HUMAN FACTORS ASSESSMENT: M9 ARMORED COMBAT EARTHMOVER (ACE)

Gregory S. Krohn
Essex Corporation

REPORT DOCUMENTATION PAGE		READ INSTRUCTIONS BEFORE COMPLETING FORM																
1. REPORT NUMBER ARI Research Note 88-12	2. GOVT ACCESSION NO.	3. RECIPIENT'S CATALOG NUMBER																
4. TITLE (and Subtitle) Human Factors Assessment: M9 Armored Combat Earthmover (ACE)		5. TYPE OF REPORT & PERIOD COVERED Final Report February 1983 - December 1985																
7. AUTHOR(s) Gregory S. Krohn		6. PERFORMING ORG. REPORT NUMBER																
9. PERFORMING ORGANIZATION NAME AND ADDRESS Essex Corporation 333 North Fairfax Street Alexandria, VA 22314		8. CONTRACT OR GRANT NUMBER(s) MDA 903-83-C-0033																
11. CONTROLLING OFFICE NAME AND ADDRESS U.S. Army Research Institute for the Behavioral and Social Sciences, 5001 Eisenhower Avenue, Alexandria, VA 22333-5600		10. PROGRAM ELEMENT, PROJECT, TASK AREA & WORK UNIT NUMBERS 2Q263739A793																
14. MONITORING AGENCY NAME & ADDRESS (if different from Controlling Office) - -		12. REPORT DATE April 1988																
		13. NUMBER OF PAGES 185																
		15. SECURITY CLASS. (of this report) Unclassified

Figure 4. Locations of the major human factors engineering deficiencies and safety hazards found on the M9 ACE. The drawings are from the Operator's Manual, Armored Combat Earthmover (ACE), M9 (TM 5-2350-262-10), Headquarters, Department of the Army, February 1984.

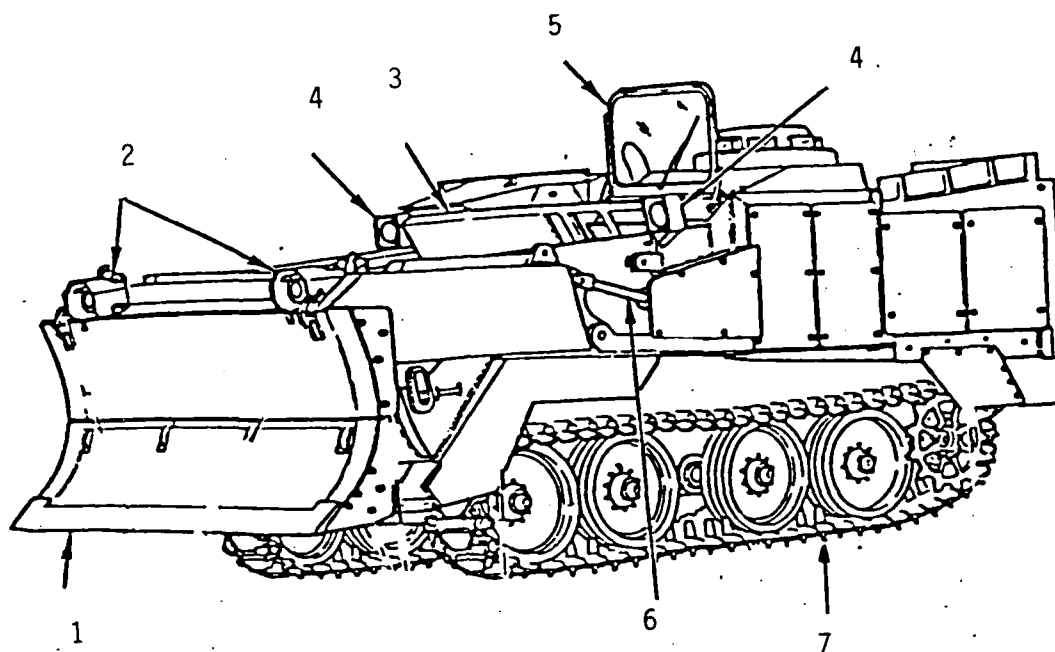
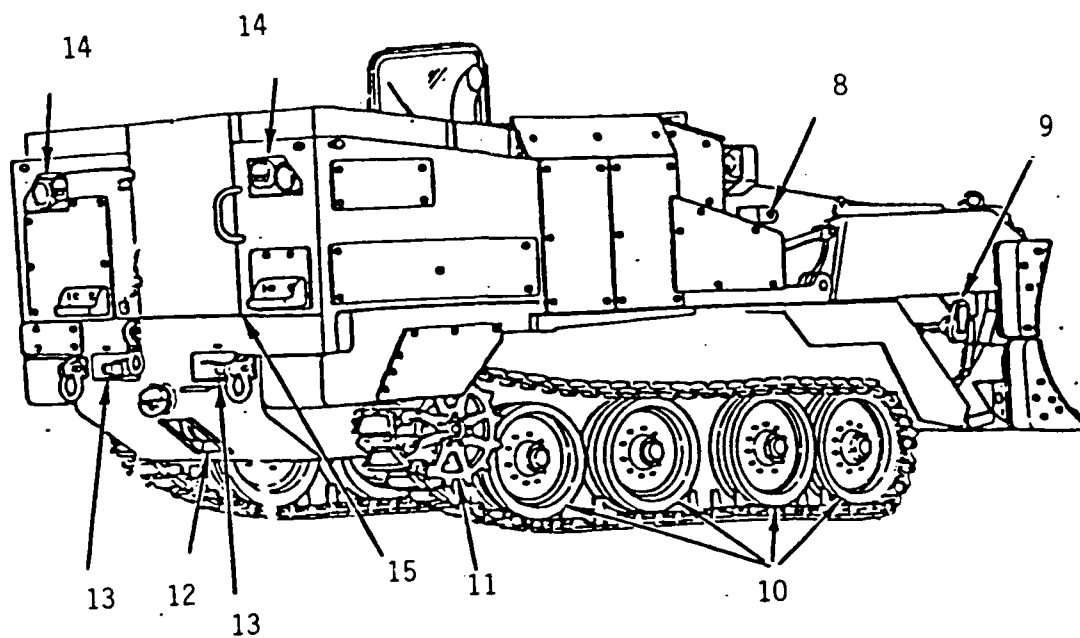
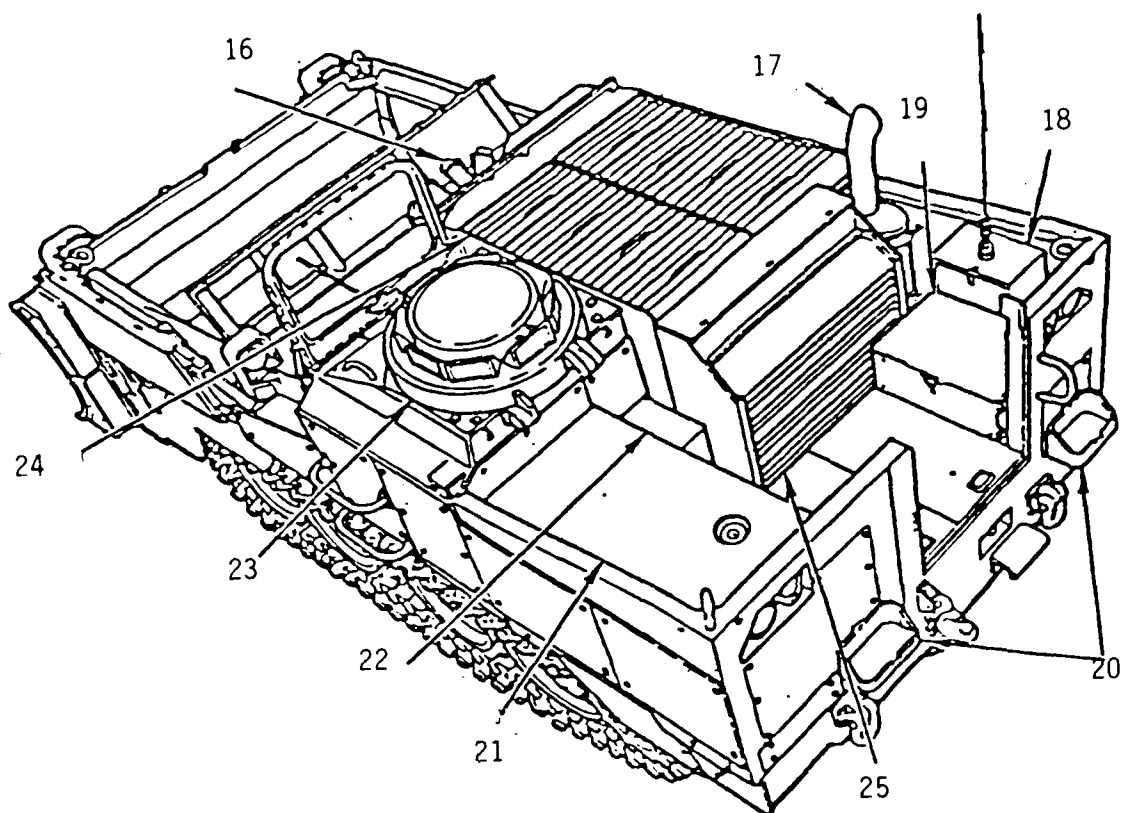
1. APRON AND DOZER ASSEMBLY. The operator must unsafely crawl beneath the dozer blade in order to prepare it for folding.
2. HEADLIGHTS. The lights do not conform to the Army Secure Lighting Program.
3. EJECTOR. There is no ejector blade lockout device to prevent its being retracted when personnel work in the bowl. The ejector cylinder (not shown) must be removed before other major components can be removed.
4. FLOODLIGHTS. The lights are frequently broken by collisions with trees.
5. WINDSHIELD. The windshield is frequently broken by collisions with trees.
6. APRON CYLINDER. The lubrication points are blocked by an armor panel.
7. TRACK. The track pads frequently wore out and may have increased vehicle vibration.

8. UPPER APRON LOCK PINS. Pin openings must be perfectly aligned in order to insert the pin. Two people are required to perform the task.
9. LOWER APRON LOCK PIN. The pins were difficult to remove due to the tightness of their fit. The pins were deformed by operators hammering them in and out of position.
10. ROADWHEELS. Rubber broke off the roadwheels and may have increased vehicle vibration. Roadwheels are hazardous to remove and replace.
11. FINAL DRIVES. The final drives must be drained in order to check the fluid levels.
12. WINCH ASSEMBLY. The winch is under capacity. The wire rope broke frequently. The wire rope wraps unevenly on the drum. There is no winch brake.
13. REAR STEP. The step was crushed in collisions.
14. TAILLIGHTS. The lights do not conform to the Army Secure Lighting Program.
15. REAR DOOR. The door is difficult to lift when installing or stowing it.

16. SMOKE GRENADE LAUNCHERS. The launchers are difficult to load from the sloped roof of the engine housing.
17. MUFFLER. Debris trapped in the muffler well was caught on fire. The radio cables were burned by heat generated from the muffler.

Visibility Test Conditions for Figures 10, 11, 12, 13, and 14

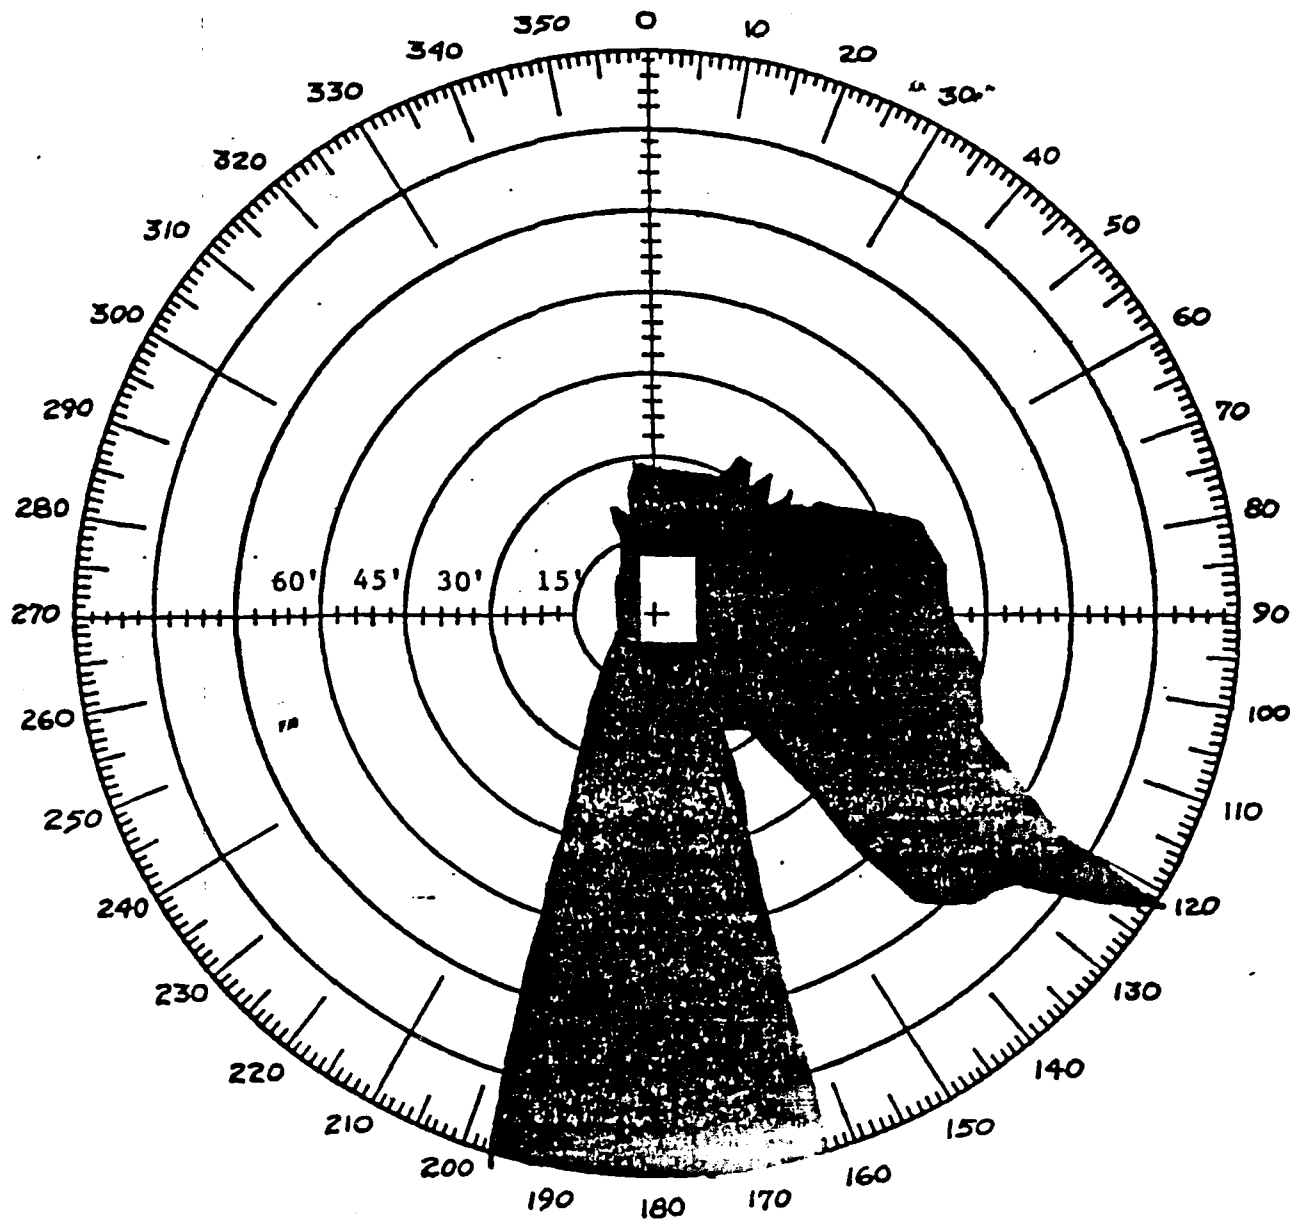
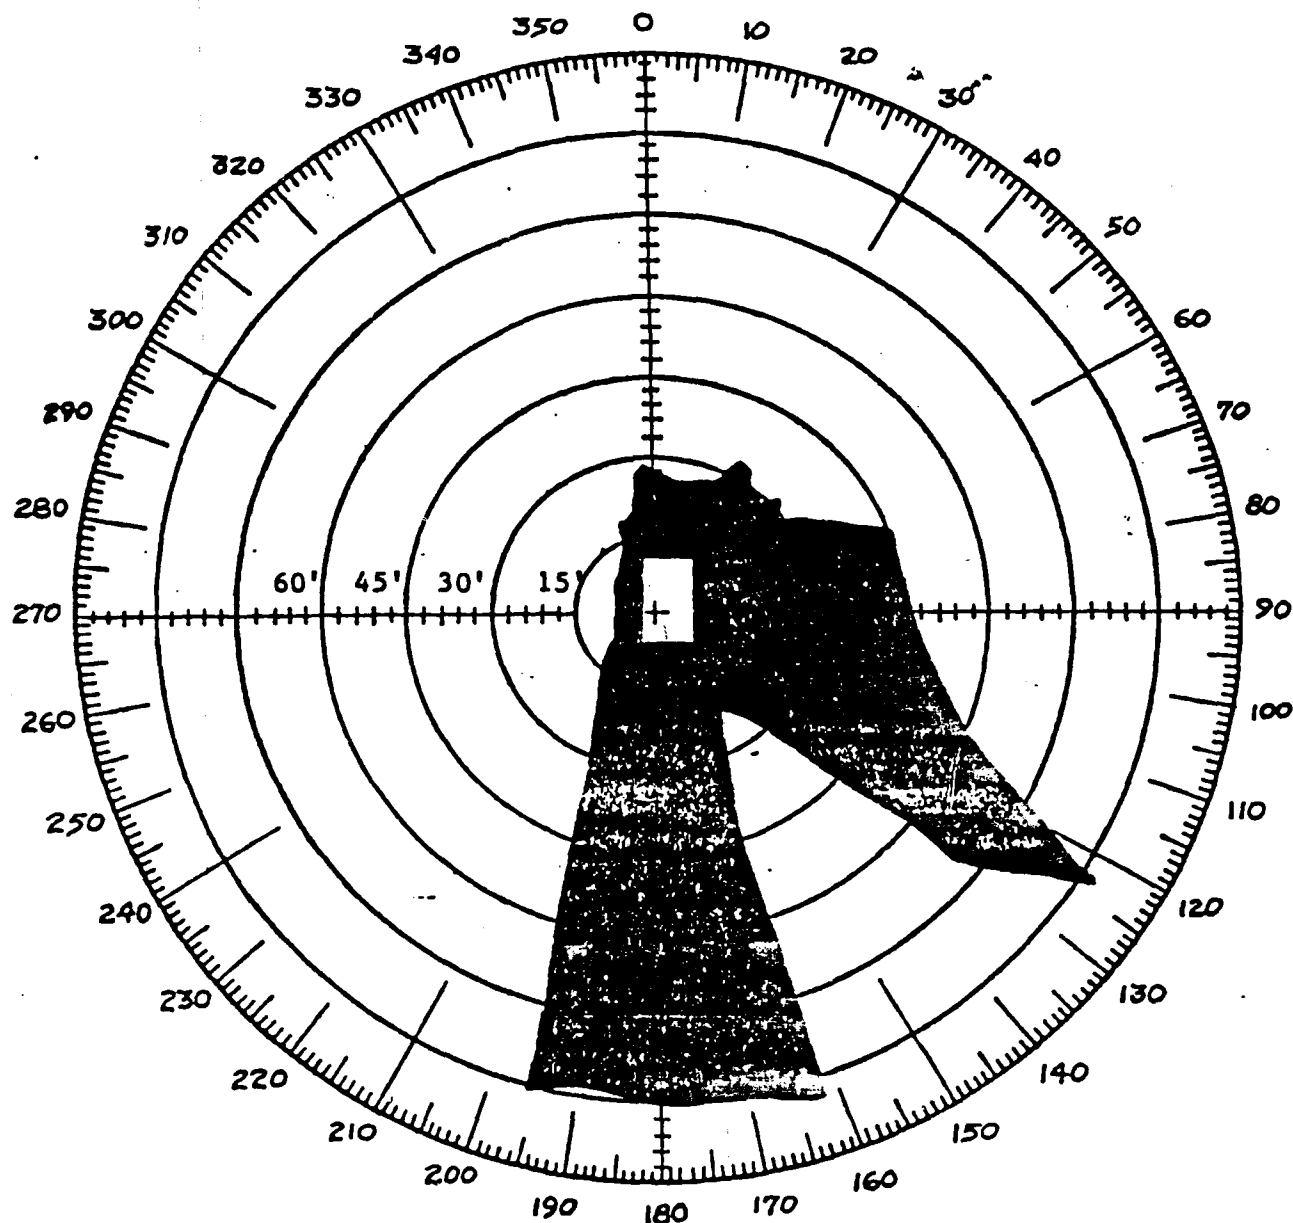
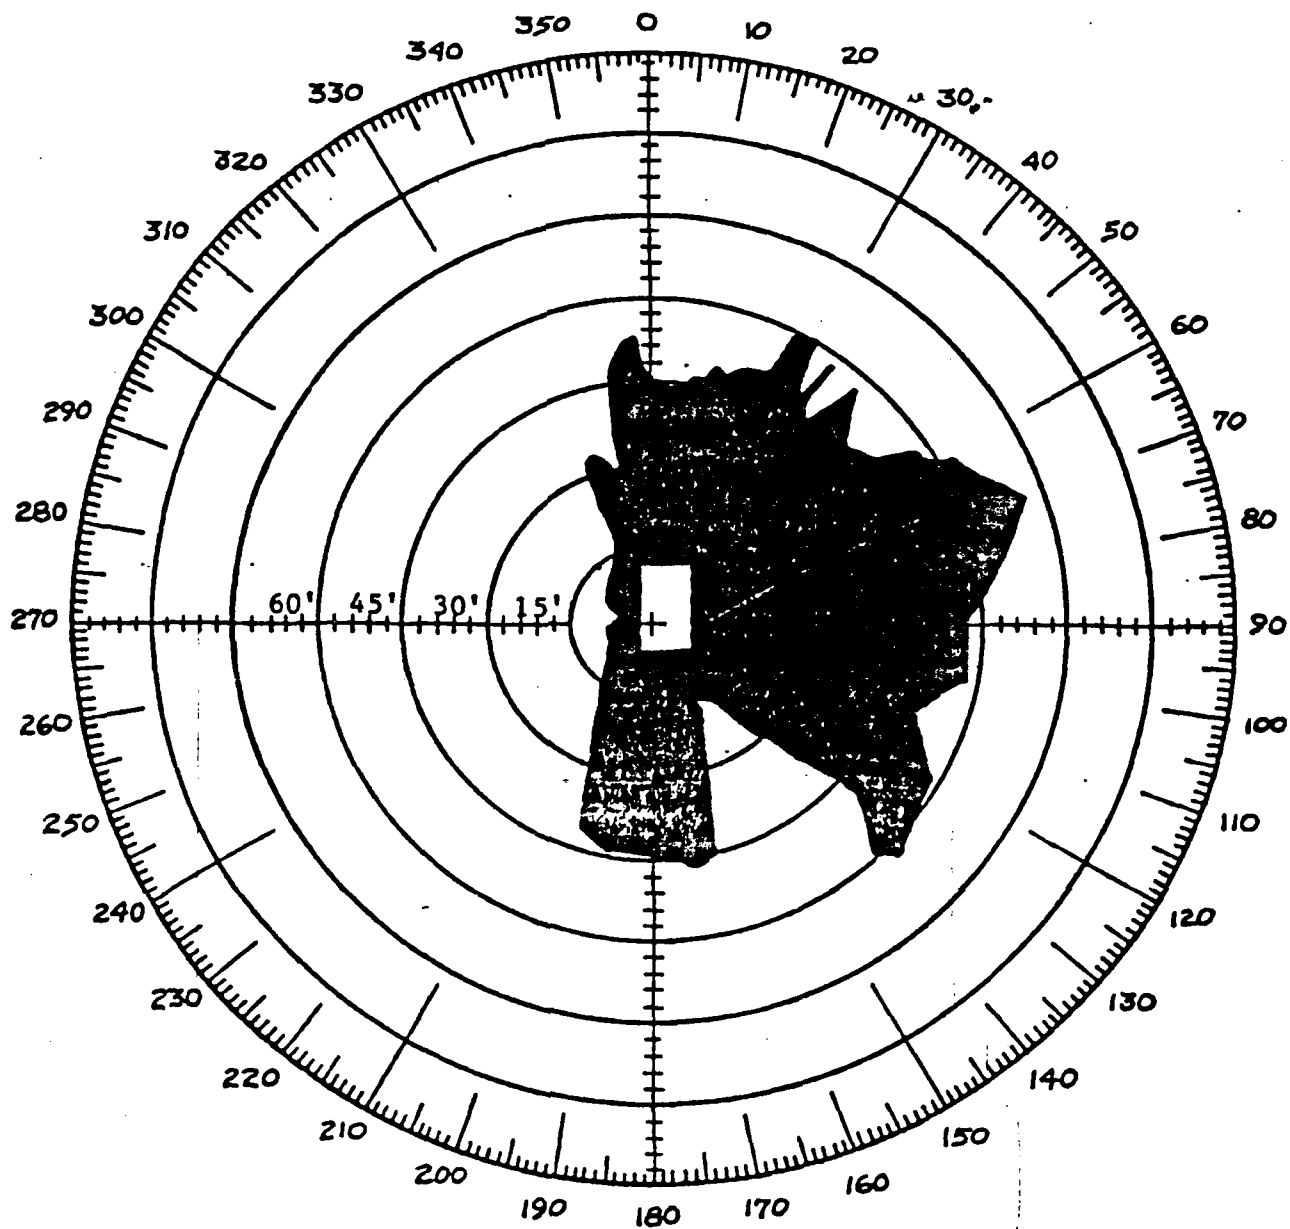
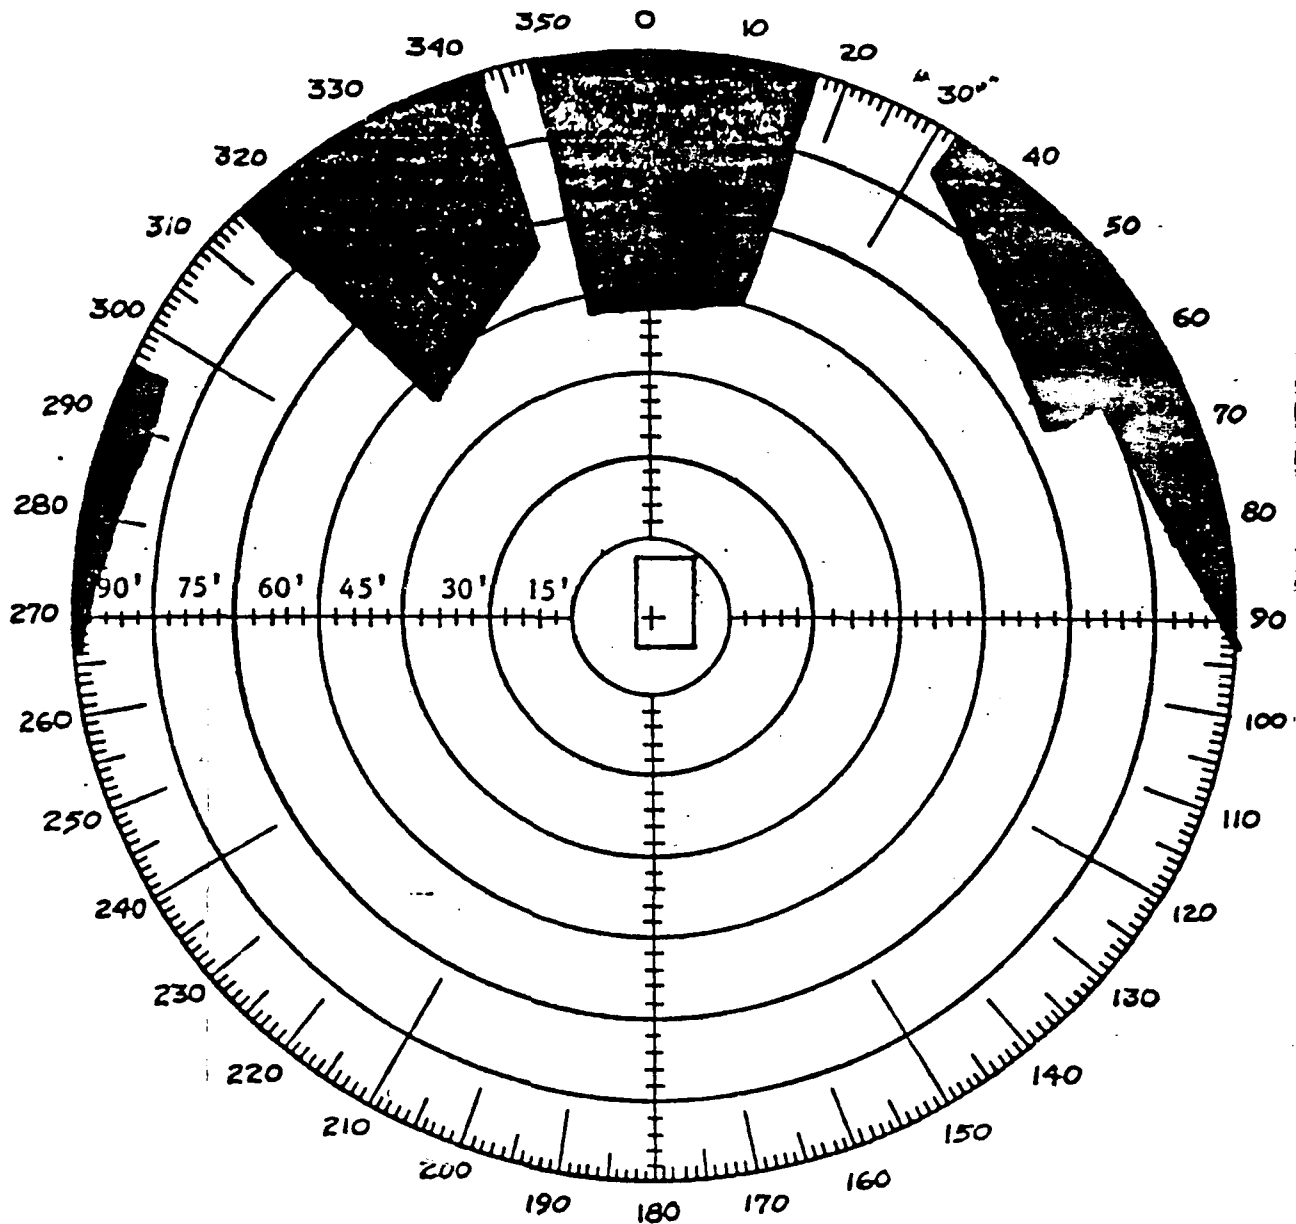
Table 14 lists Figures 10, 11, 12, 13, and 14 from the FA-IPT and describes the visibility test conditions for each figure.

Figure 18. The damage to the rear of the vehicle. (The winch cable, the rear steps, the jerry can holders, and the handrails are broken.)

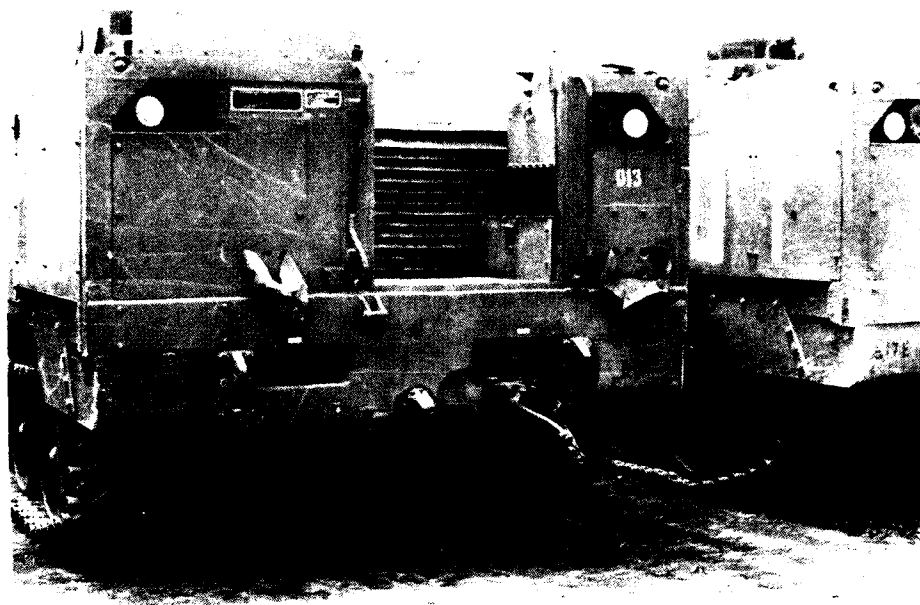
Description of the Deficiency: Table 17 lists the number of operators responding to questions concerning the space provided for stowage and its locations. Figure 18 shows damage to jerry can holders and other objects on the rear of the vehicle. Table 18 lists the specific stowage deficiencies for basic issue items (BII) and other equipment.

Implications for the Operator and the Equipment: Stowed equipment on the rear of the vehicle was frequently damaged by collisions with objects to the rear of the vehicle. Stowed equipment on the rear deck of the vehicle was affected by the high engine temperature. The stowed equipment blocked the air flow and affected the efficiency of the cooling system. Stowage locations that are difficult to access increase the time it

Potential Solutions: The Final Report of the First Article-Initial Production Test (1984) recommended a complete review of the stowage space provided on the M9 ACE and its load plan. In addition to a complete review, several specific recommendations include:

1. Add a rear bumper that extends along the lower rear of the M9 and up both of the outside edges. The bumper should be wider than any of the stowed items kept at the rear of the vehicle and the outside edges should be wide enough to deflect tree limbs. The rear bumper could also include an improved rear step and mount for the winch.

2. Increase the length and depth of the OMV tool box to accommodate the additional equipment (ie., the tanker bar, life jacket, canvas canopy, etc.).
3. Add steps and handholds to assist operators when climbing into the bowl in order to make access to the tool box easier and safer.

4. Add a mechanism on the tool box lid to lock it open and to avoid having it fall on the operator.
5. Add stowage compartments on the rear of the vehicle and protect them from being crushed.

Figure 30. Damage to the floodlight guard

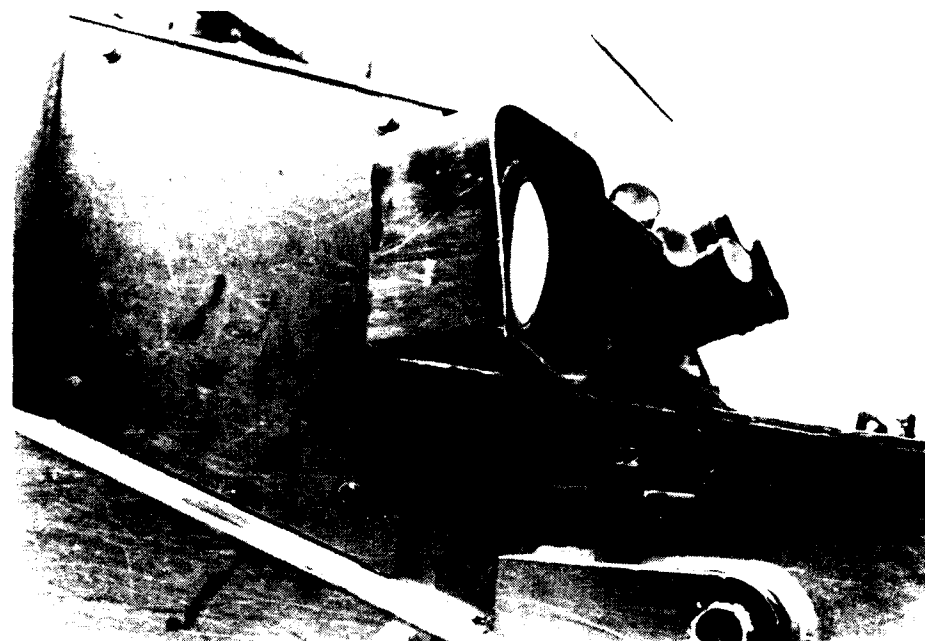
Description of the Deficiency: Figure 30 shows a damaged protective shield for a floodlight mounted on the side of the vehicle. The side mounted floodlights were frequently damaged by collisions with trees.

1. Place the side mounted floodlights in protected locations more inboard on the vehicle than the present locations. Perhaps, floodlights could be located inboard at a greater height on a removable stand or fixture.
2. Add lights meeting the requirements of the Army Secure Lighting Program.
